UNITED STATES PATENT AND TRADEMARK OFFICE

APPLICATION NO.	FILING DATE	FIRST NAMED INVENTOR	ATTORNEY DOCKET NO.	CONFIRMATION NO.
09/766,025	01/19/2001	William R. Voigt	1515.3001.001	7873

Office Action Summary

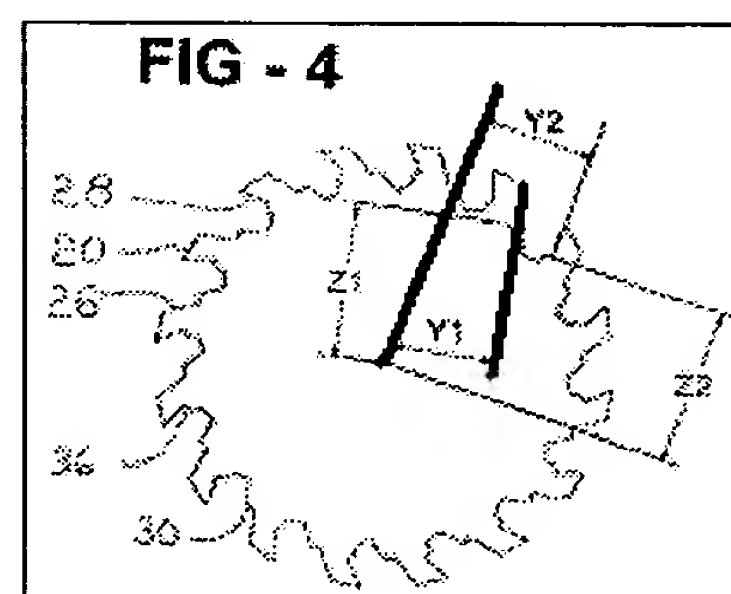
2. The drawings are objected to because the dimension as noted by (Y1) in figures 4-8 is confusing and does not clearly illustrate a particular dimension of the invention. Dimensional markings of this nature generally consist of two parallel lines extending from a defined point on the object of the drawing.

The extensions of (Y1) in figures 4-8 are not parallel and, therefore, it is unclear what dimensions they are actually defining. Please see the figure to the right for an illustration regarding this objection.
